Hualapai Planning & Economic Development Department and  
Hualapai Tribal Utility Authority

**Request for Proposal for  
Power Line, Substation and Other Engineering Design Services**

**ADDENDUM NO. 1**

## Exhibit D from Plan of Development

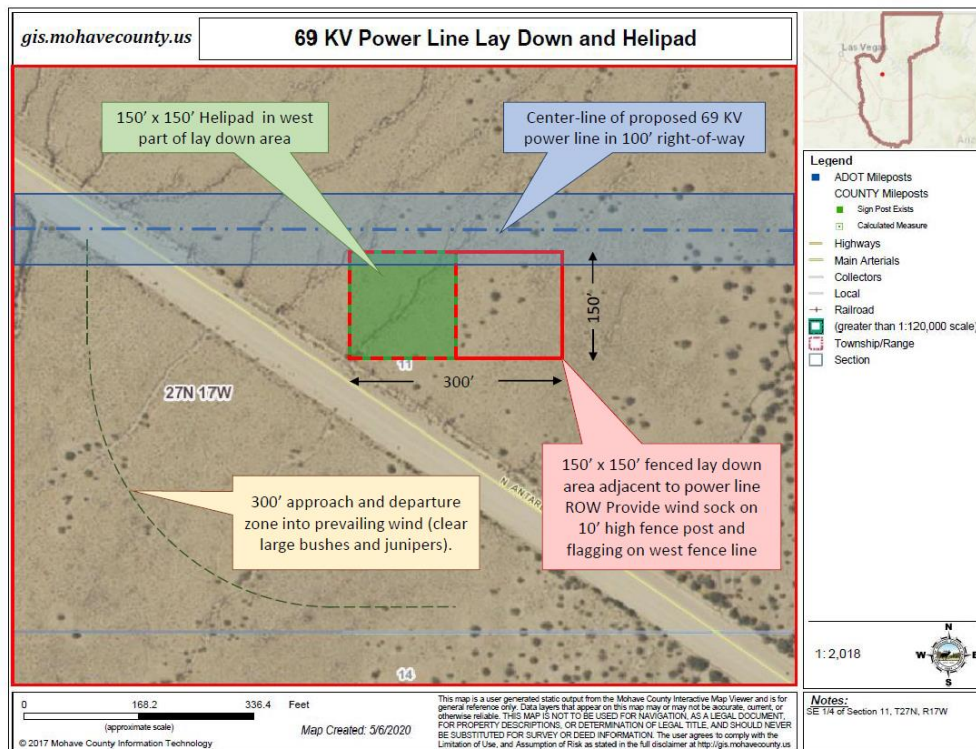
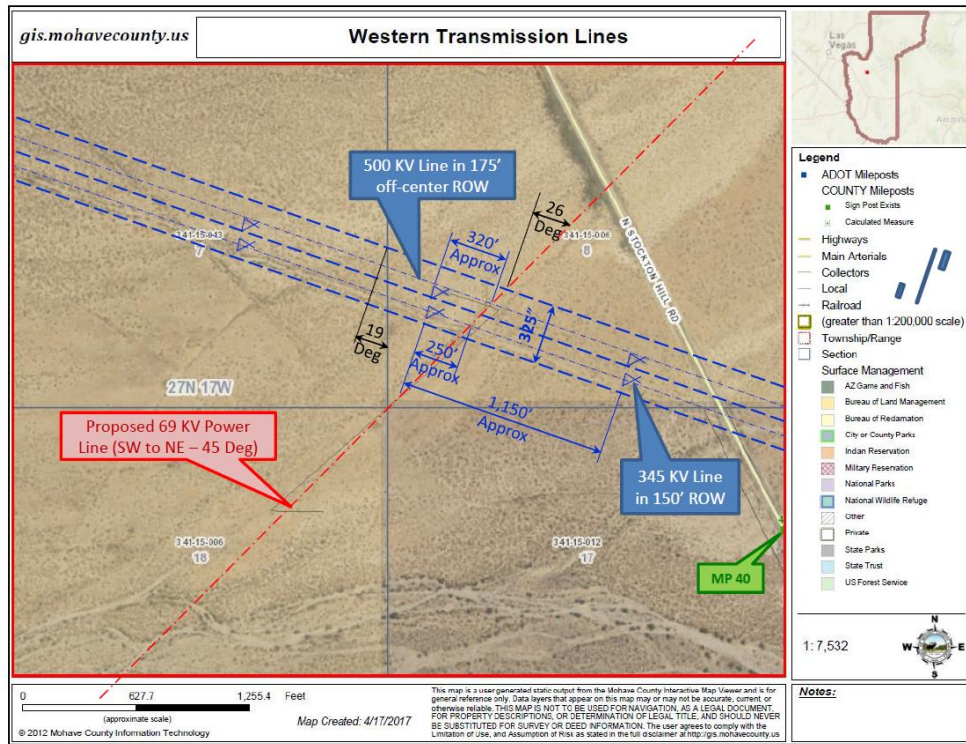
5. ***In what jurisdiction(s) do the sub-station and lay-down areas reside?*** The sub-station and first lay-down area are on tribal land, with the second lay-down area being on public lands just east of Antares Road (see attached Exhibit D from Plan of Development).

# Alternate Alignments for 20.8 KV Feeder from Grand Canyon West Substation to Switch No. 1

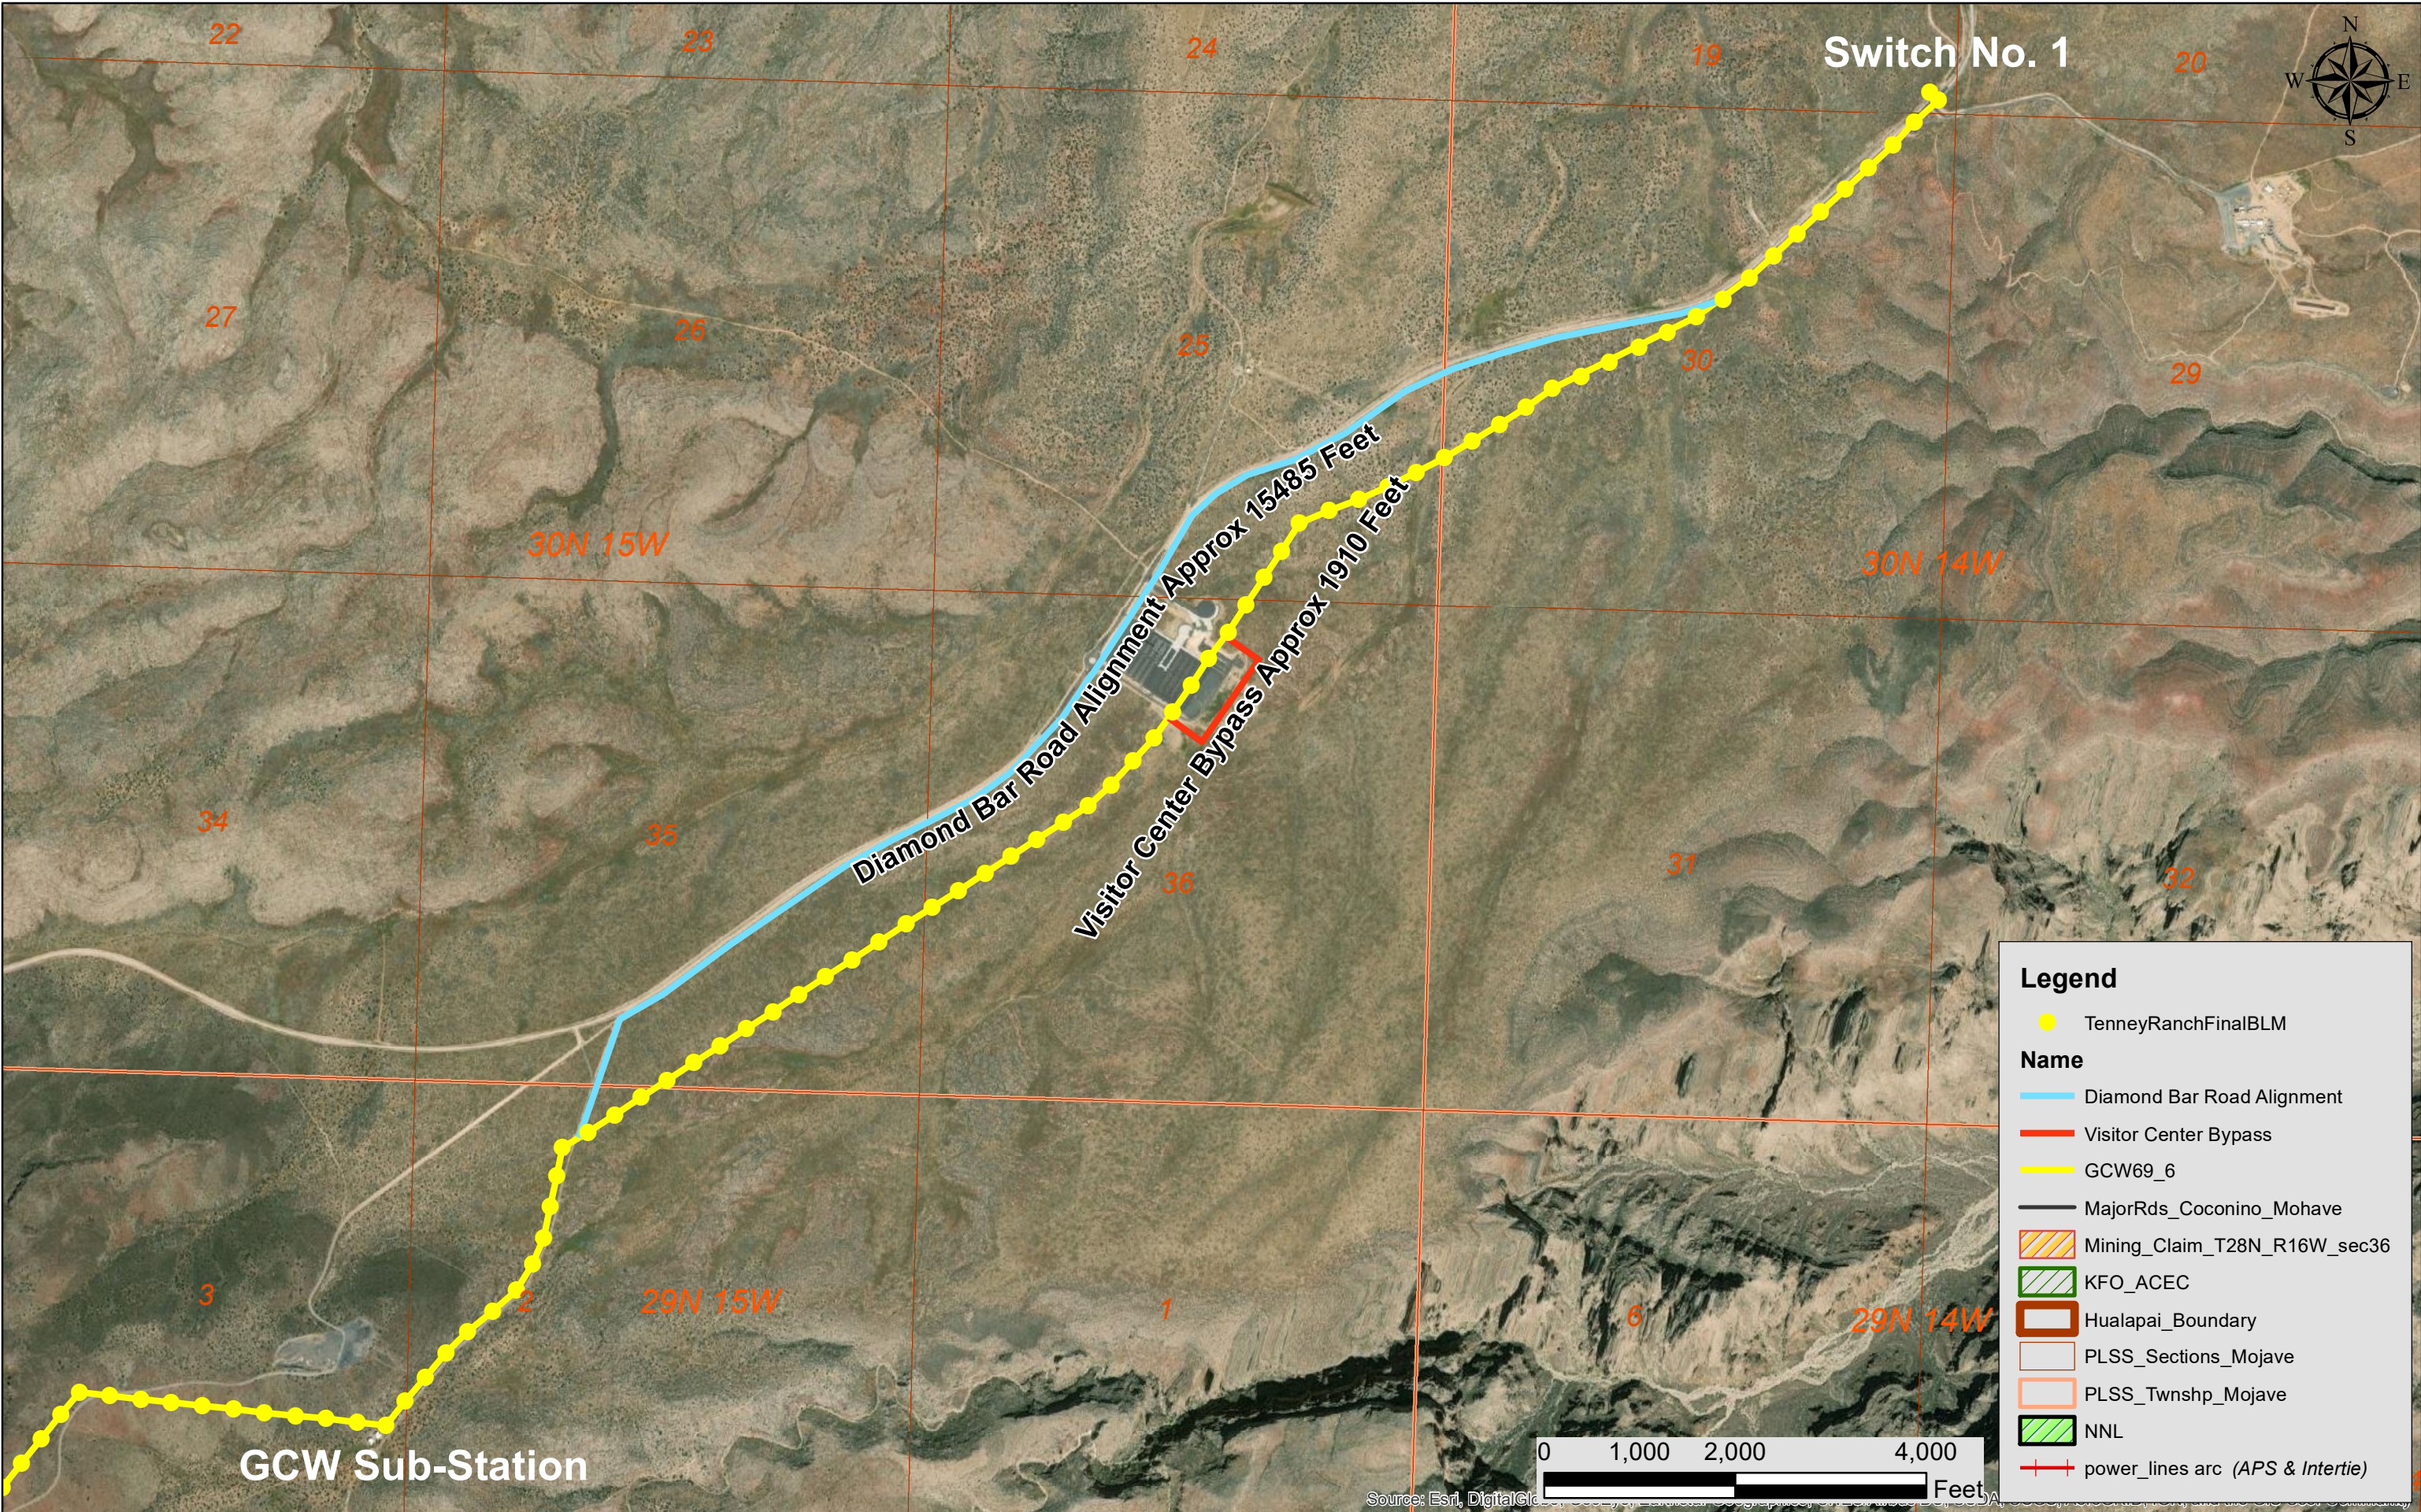
6. ***Does they HTUA have a geotechnical standard to adhere to?*** Not at this time.
7. ***What is the preferred or minimum depth for the 20.8 KV feeder line between the new substation and the existing micro-grid switch on Diamond Bar Road?*** Ideally, a 48" trench depth can be obtained; however, the HTUA is open to a hybrid, value-engineered solution. Please note the feeder line must negotiate a new parking lot. See attached map for alternate path around parking lot and a second path, designed only for only the buried line option that follows Diamond Bar Road to Switch No. 1.
